U.S. Department of Transportation  
**Pipeline and Hazardous Materials  
Safety Administration**

Ref. No. 09-0136

RE: DOT-412 Specification Cargo Tank Requirements

*Figure 3 – Ring Stiffener Drain Hole (Forward Ring)*

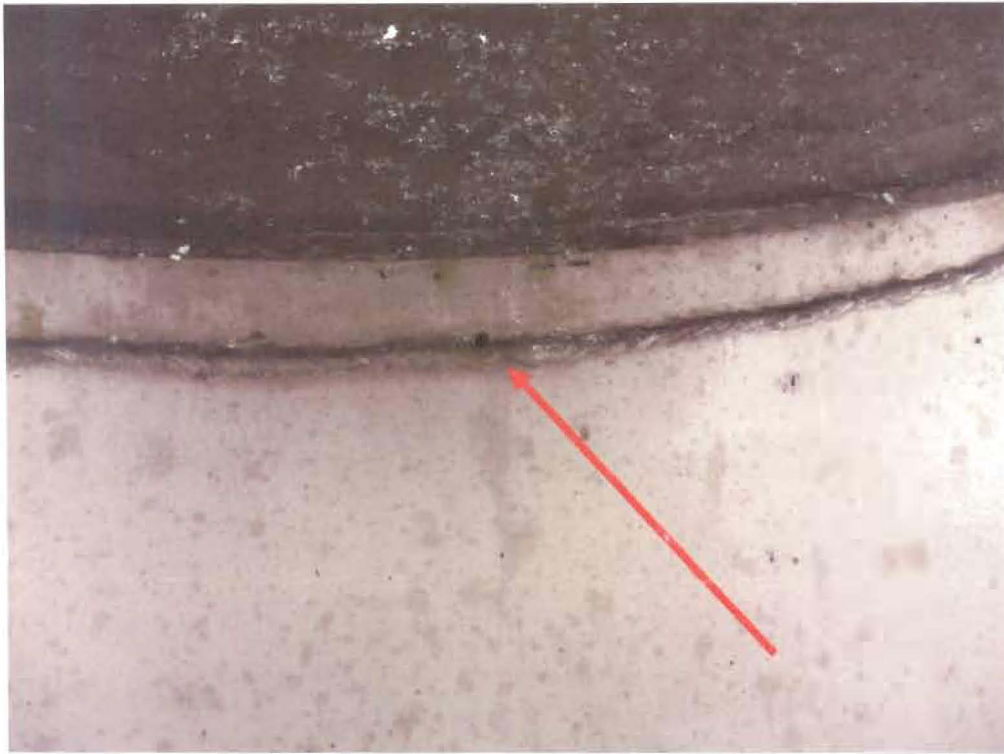
Q2. Our company's DOT 412 CTMVs were found to be in violation of the venting and drainage requirements for ring stiffeners that enclose an air space under § 178.345-7(d)(4). What is the appropriate location for ring stiffener drains? Must the vents be visible to verify compliance?

Now, just over a year later, the trailer discussed in Question 1 above was also cited for not having drain holes in the ring stiffeners to which the under-ride frame is mounted, in spite of the fact that there are holes present in the ring stiffeners as discussed in the previous paragraph (*see Figures 3 and 4*). In light of these inspections, I am looking for specific information regarding the requisite location of ring stiffener drain holes. The regulation is somewhat vague in this regard, stating only that any air spaces enclosed by ring stiffeners must "*be arranged for venting and be equipped with drainage facilities which must be kept operative at all times.*" Obviously, there is nothing in the regulation that fixes the specific location of such "*drainage facilities*". What locations are acceptable for such drain holes, and are drain holes located as are those in the accompanying photographs adequate for compliance with §178.345-7(d)(4)?

A2. The HMR do not explicitly dictate the location of vented drains in the enclosed air space of a ring stiffener. It is the opinion of this Office that a ring stiffener drain or vent should be visible, as far as practicable, in order to verify compliance with the HMR. Additionally, there is no need to install multiple vents or drains when only one satisfies the intent and functionality of the requirement.

Figure 1 – Trailer Specification Plate

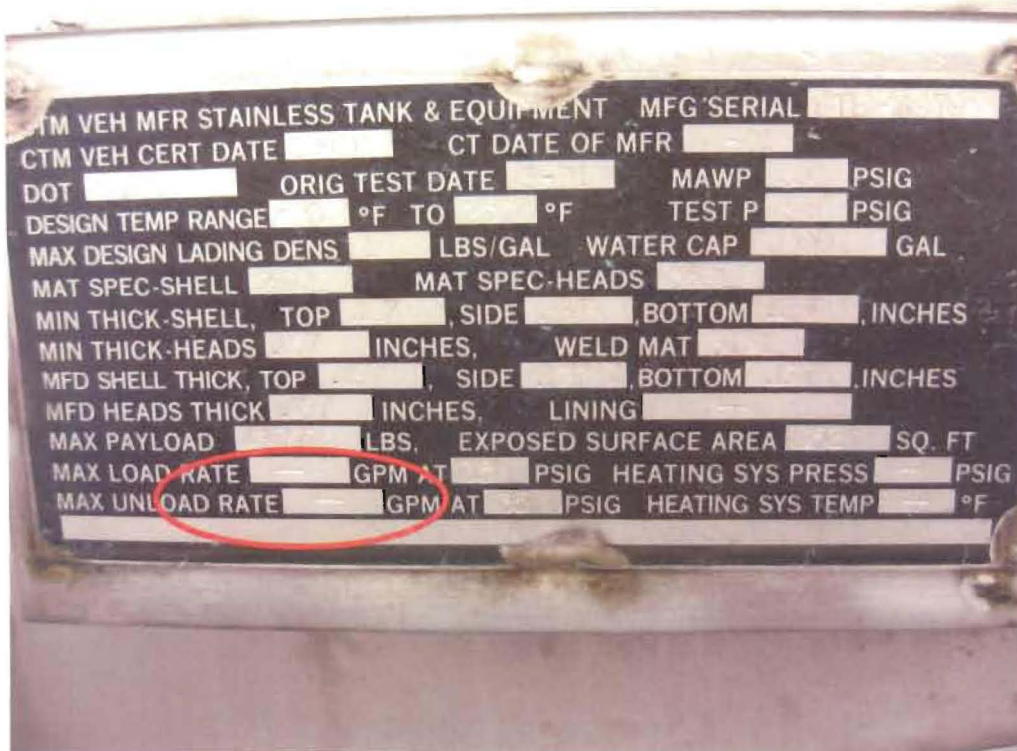
Q1. Under § 178.345-14(c)(6) and (c)(7), the maximum loading and unloading rates in gallons-per-minute must be marked on the specification plate of a DOT 406, 407 and 412 CTMV. The manufacturer of our variable specification DOT 407/412 CTMVs only marks the pressure on the specification plate at which the maximum loading and unloading rate is given as a hyphen that denotes no limit is placed on the flow rate. Is this practice correct?

The first issue involves information required to be marked on the DOT-412 specification plate per 49 CFR §178.345-14(c)(6) and §178.345-14(c)(7). The regulation states that the maximum loading rate in gallons per minute and the maximum unloading rate in gallons per minute are to be marked on the plate. The vehicle in question is a 2001 Stainless Tank & Equipment (ST&E) DOT-407/DOT-412 cargo tank motor vehicle. Although maximum loading and unloading *pressures* are shown on the specification plate, the *rates* are not shown; instead, a line is marked in the blocks provided for the loading and unloading rates (see Figures 1 and 2). In a telephone conversation earlier today, Mr. Paul Kreuger of ST&E's Engineering Department stated that the specification plate is so marked because there is no limitation placed on the maximum loading and unloading rates for this tank. He further stated that very few of ST&E's cargo tanks of this type have such a limit, and that therefore the specification plates of those tanks are also not marked with maximum loading and unloading rates. Having been charged with a violation of §178.345-14(c) for these limits not being marked on the specification plate, I now must ask what the proper marking should be if the manufacturer does not impose an upper limit on loading and unloading rates, and if a plate marked as shown in Figure 1 is in violation?

A1. No. As specified in the introductory text under § 178.345-14(c), the maximum loading and unloading rate in gallons-per-minute entry is required regardless of its applicability or appropriateness.
